2017SSH028 – 49-57 GERRALE STREET, CRONULLA

DA17/0885

ASSESSMENT REPORT APPENDICES

DRAFT CONDITIONS OF CONSENT
Development Application No. 17/0885

A100 K

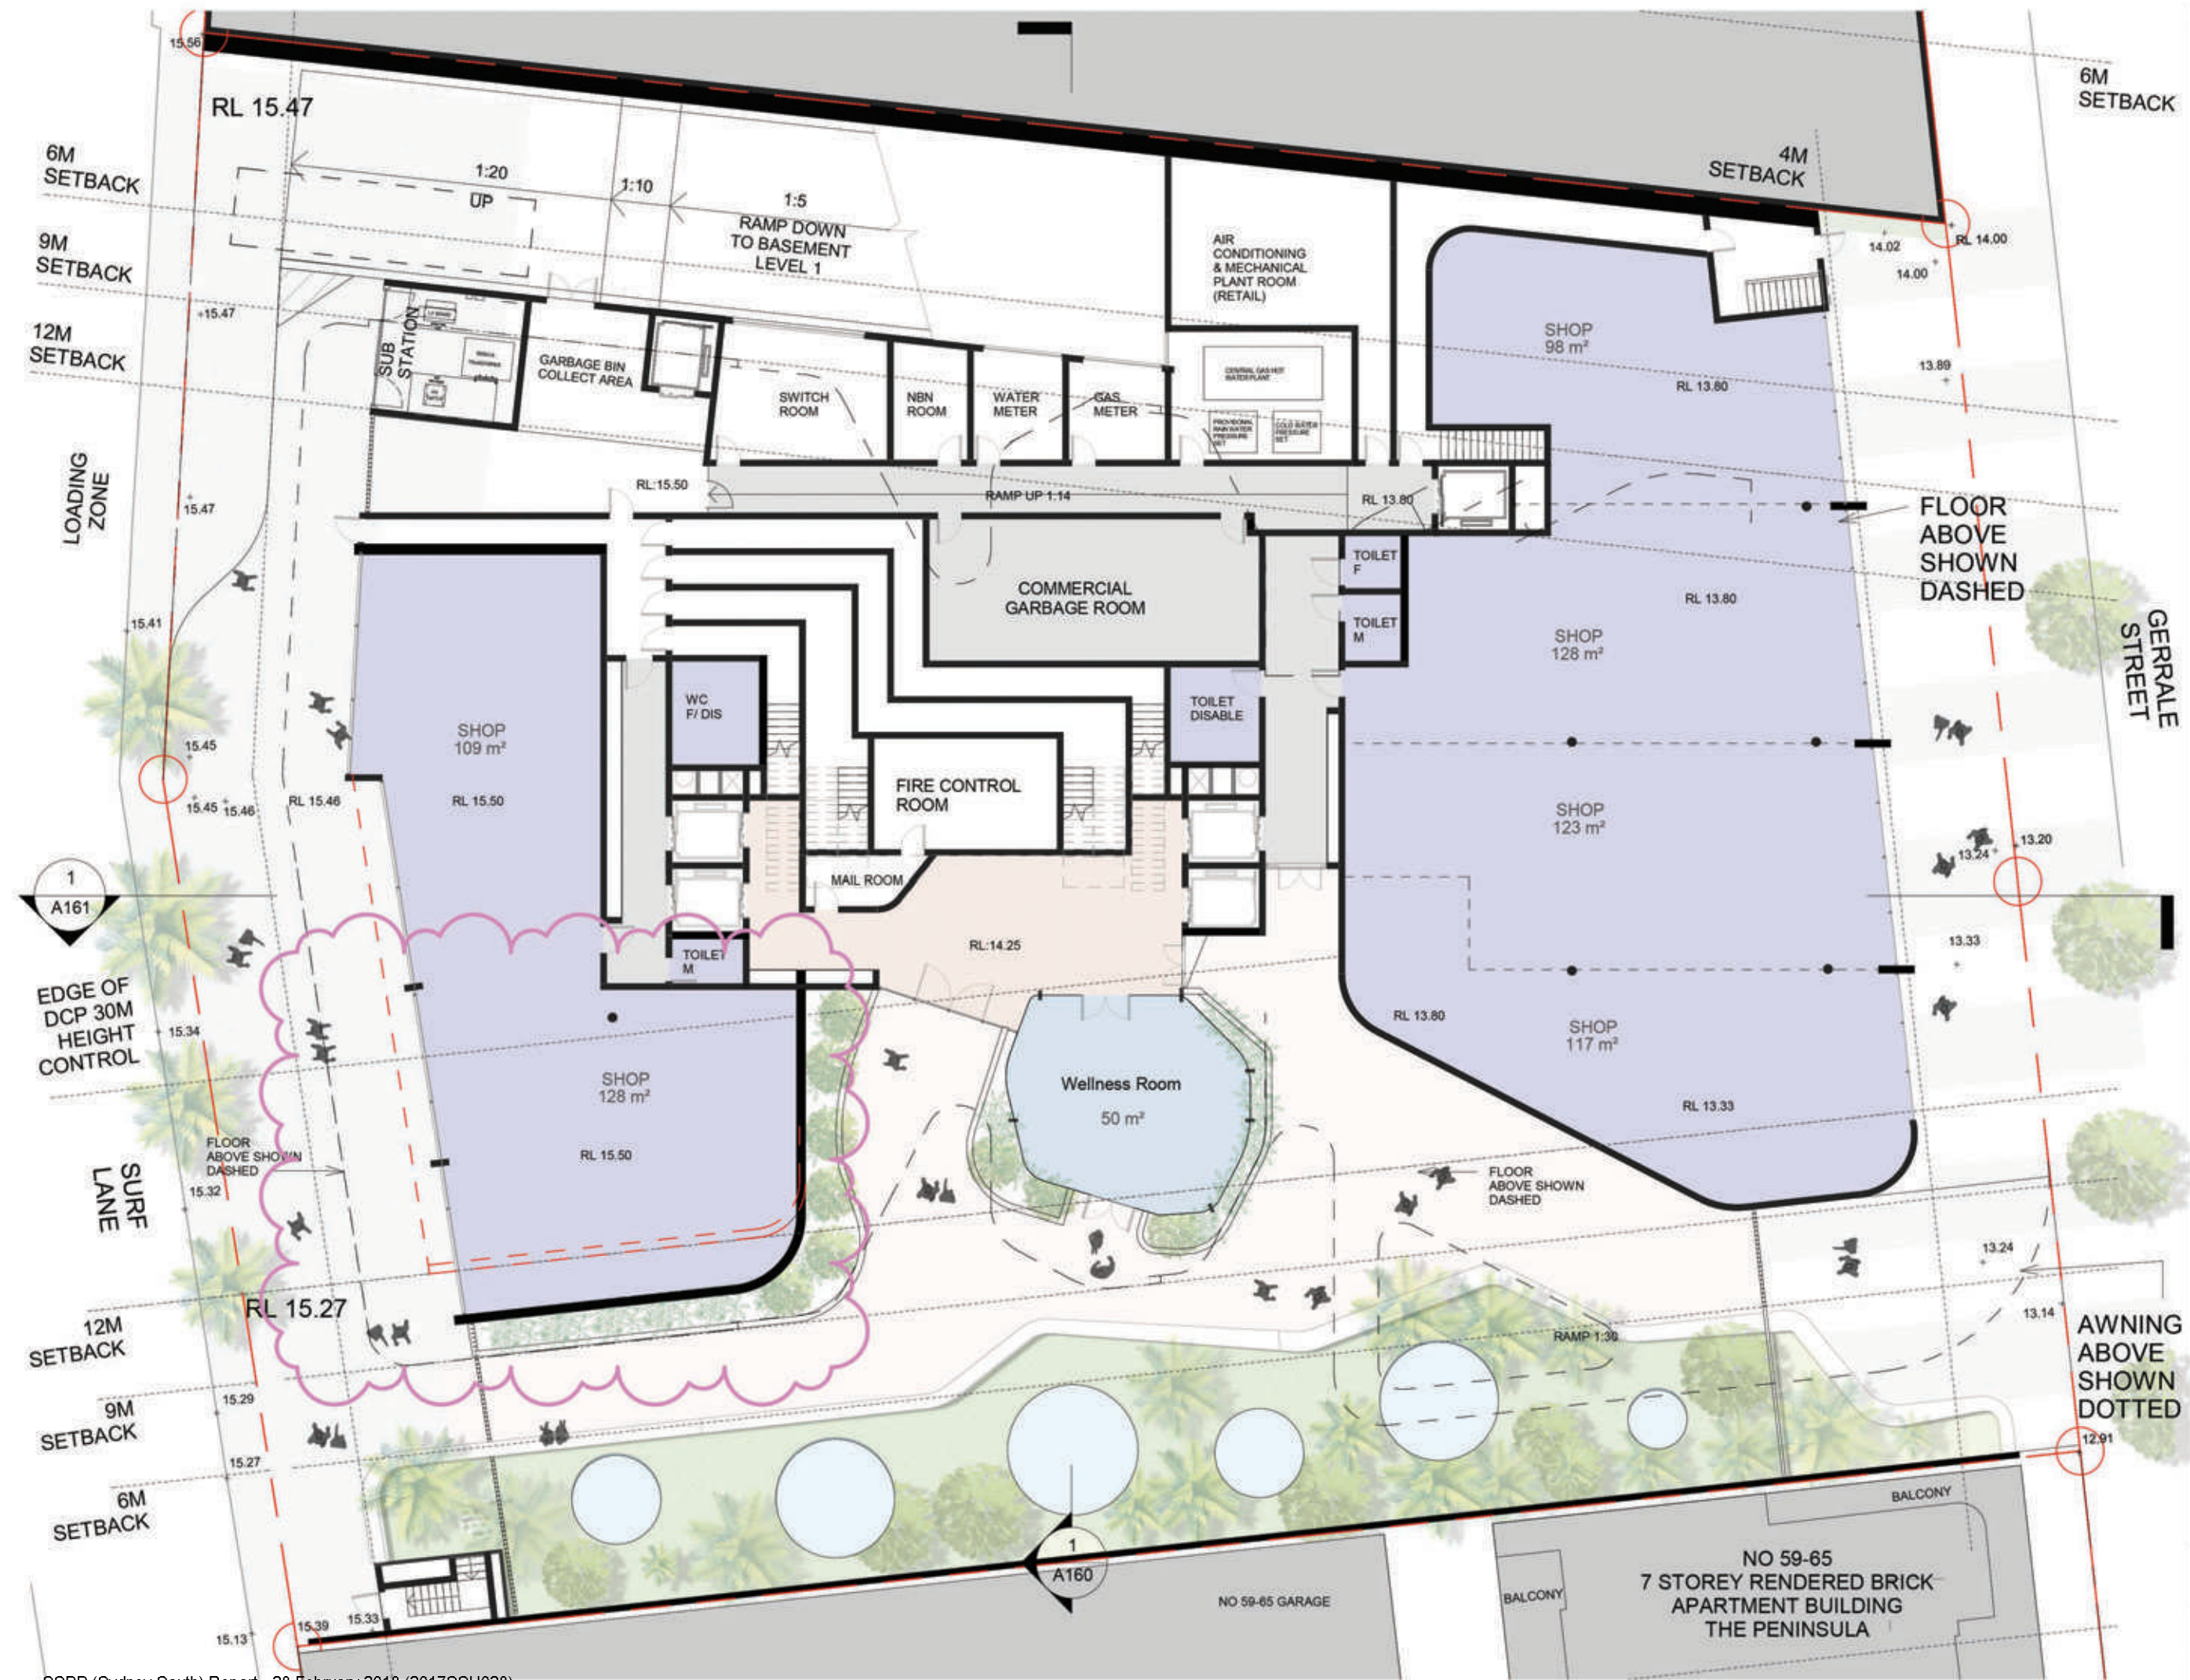
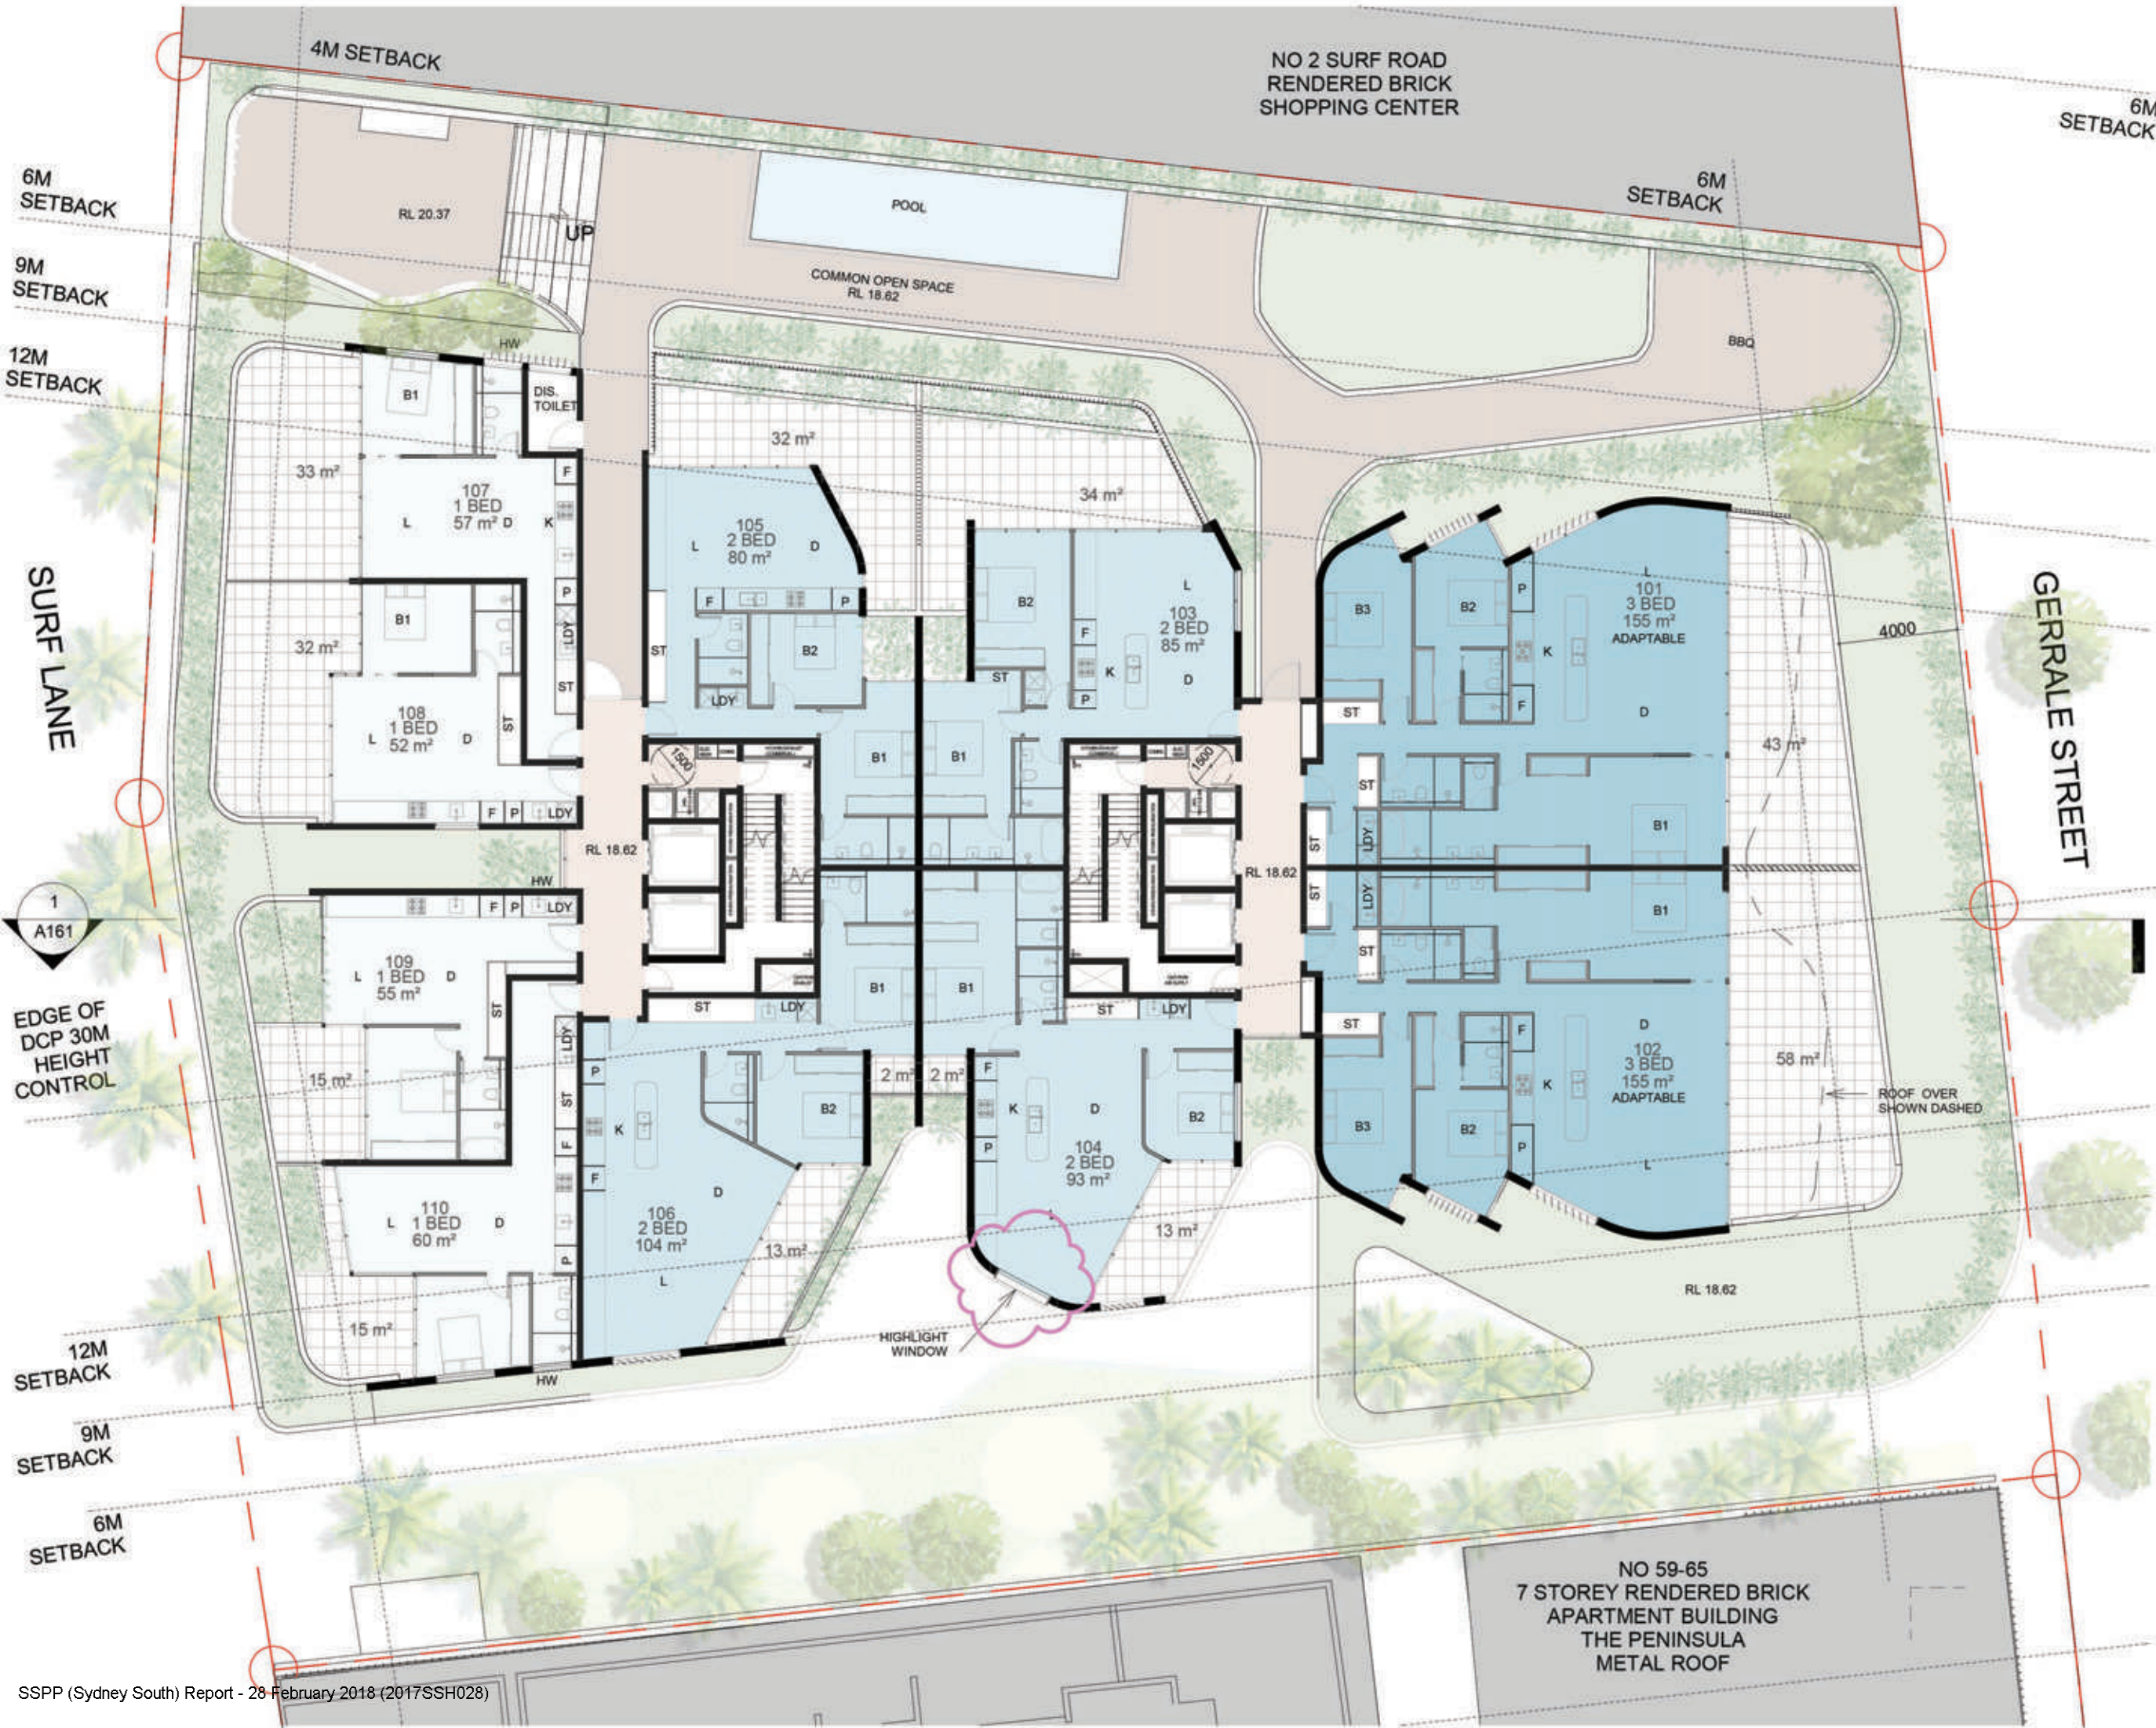
- ii) Unobstructed internal access must be provided from the Gerrale Street tenancies to the commercial garbage room and Surf Lane loading area. This will require the deletion of the wall shown on Ground Floor Plan A100 Rev K;
